Access Compliance Report

Public Rights-of-Way

(Curb Ramps)

Intersection ID: 13404	Main Street: LEXINGTON_AV	Cross Street: E_CARSON_BV	Location:	N
ADA ID: CBD26B61B429	Ramp Type: BlendTrans1	Initial Pass/Fail: Fail	Overall Compliance: No	Severity Score: 8.75
Codes/Mitigation Info/Possible Solution		Field Measurements/Component Compliance

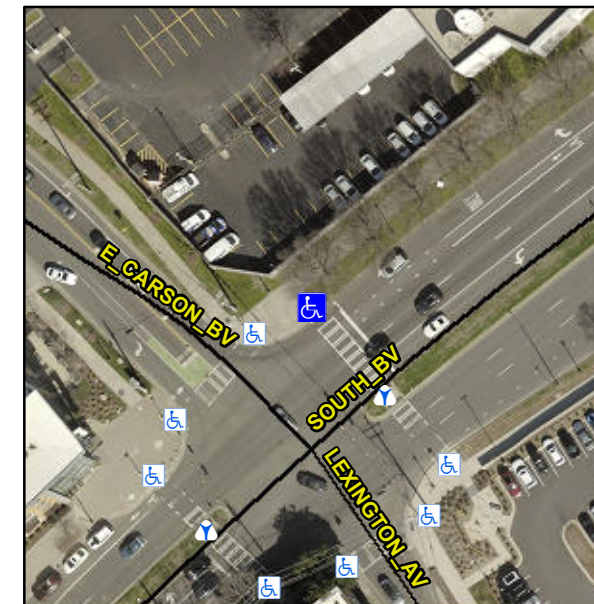
Not Found, R304.5.1

Compliance	Description	Data	Compliance	Description	Data
N/A	Ramp Length (in)	96.0	Yes	BlendTrans Slope (%)	4.3
No	Ramp Width (in)	45.0	Yes	BlendTrans XSlope (%)	1.6
N/A	Flare Type LT	N/A	N/A	Flare Type RT	N/A
N/A	Flare Slope LT (%)	N/A	N/A	Flare Slope RT (%)	N/A
N/A	Flare Traversable LT?	N/A	N/A	Flare Traversable RT?	N/A
N/A	Landing Length (in)	N/A	N/A	DWS Provided?	N/A
N/A	Landing Width (in)	N/A	N/A	DWS Contrast?	N/A
N/A	Landing Slope (%)	N/A	N/A	DWS Length (in)	N/A
N/A	Landing X Slope (%)	N/A	N/A	DWS Full Width?	N/A
N/A	Landing Curb? (Y/N)	N/A	N/A	DWS Offset (in)	N/A
N/A	Shared Landing?	N/A			
N/A	Gutter Ponding?	N/A	N/A	Gutter Slope (%)	N/A
N/A	Gutter Lip Ht (in)	N/A	N/A	Gutter X Slope (%)	N/A
N/A	Painted X Walk1?	Yes	N/A	Painted X Walk2?	N/A
	X Walk 1 Direction	To SE		X Walk 2 Direction	N/A
	X Walk 1 Width (in)	112.0		X Walk 2 Width (in)	N/A
	X Walk 1 Slope (%)	4.5		X Walk 2 Slope (%)	N/A
	X Walk 1 X Slope (%)	1.3		X Walk 2 X Slope (%)	N/A

N/A	Ramp inside XWalk1?	Yes	N/A	Ramp inside XWalk2?	N/A
	Road Slope (%)	1.3		Clear Space?	N/A
	Road X Slope (%)	4.5	N/A	Clear Space to XWalk (in)	N/A
N/A	Any Obstructions?	N/A	N/A	Storm Grate/Utility Hazard?	N/A
	Obstruction Type			Storm Grate/Utility Type	
		N/A			N/A
			Yes	Surface Condition? (G/P)	Good
			No	Curb Slope (%)	8.8

Remove & Replace Curb Ramp With Two New Directional Ramps or Equivalent.
